UNITED STATES PATENT AND TRADEMARK OFFICE

APPLICATION NO.	FILING DATE	FIRST NAMED INVENTOR	ATTORNEY DOCKET NO.	CONFIRMATION NO.
10/806,718	03/23/2004	Michael Joist	1689.007US1	2652

Office Action Summary

DETAILED ACTION

Fig. 1a

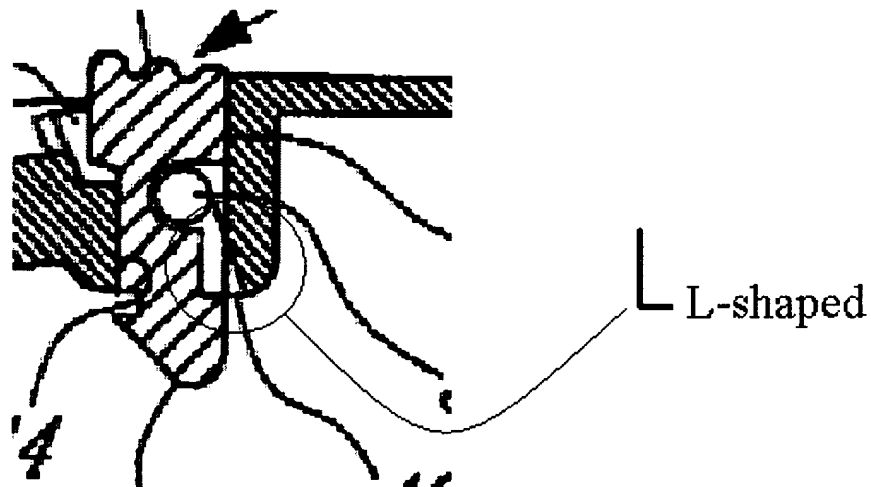
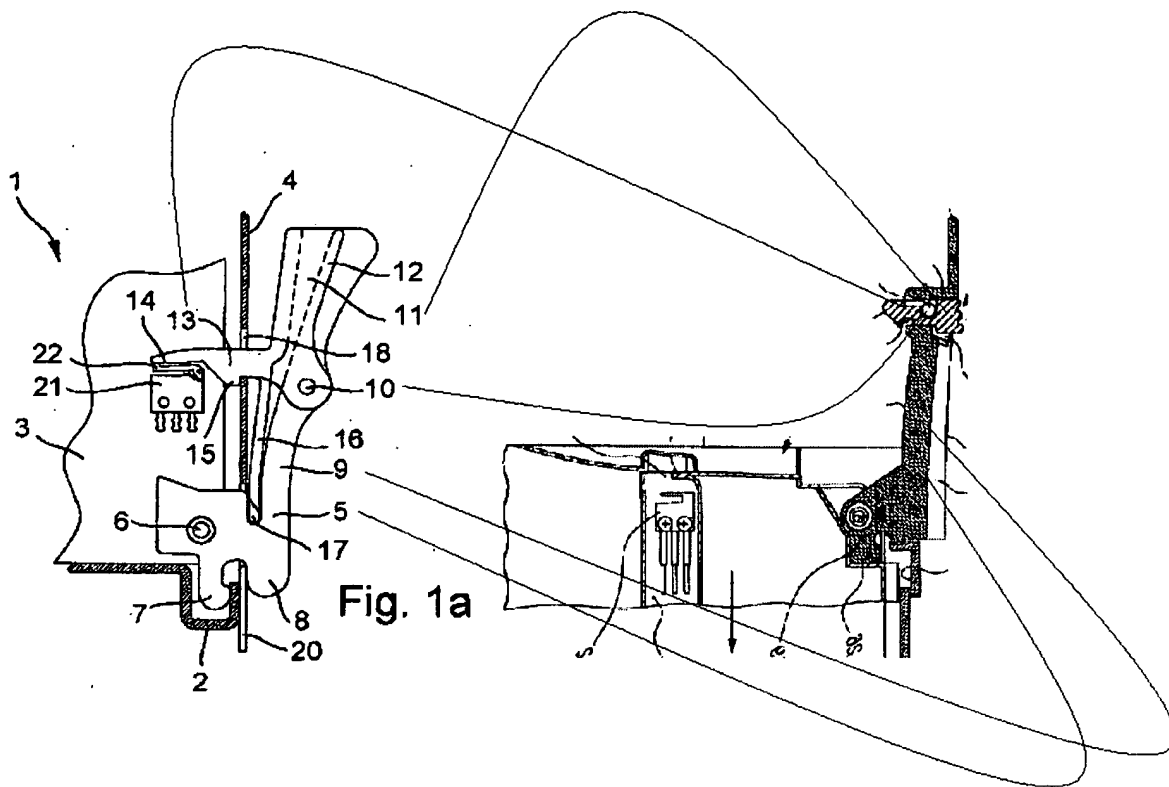
-- In reference to Claim(s) 1, Stathopoulos shows (see examiner's figure)

a swivel-mounted lever/pull handle (see examiner's figure) with located in a frontal area of the plug-in module, the lever/pull handle including a gripper arm which is an integral part of the lever/pull handle; and

a control lever (see examiner's figure) that contains a profile in the shape of an L is rotatably connected to the gripper arm (see examiner's figure) of the lever/pull handle, wherein the control lever includes a stepping pawl (see examiner's figure) to operate the switch when the plug-in module is completely inserted.

-- In reference to Claim(s) 3, Stathopoulos shows (cover sheet) a front plate (see examiner's figure) with a void, which forms the locking edge (near the lead line of numeral 32 (cover sheet)) and through which the stepping pawl reaches.

-- In response to applicant's assertion that neither reference shows an L-shape within the control lever, the examiner disagrees. Stathopoulos is seen to show a shape the is in the form of the letter L in the control lever 30. Further, with regard to Han, a change in shape is seen to be well within the level of one skilled in the art.
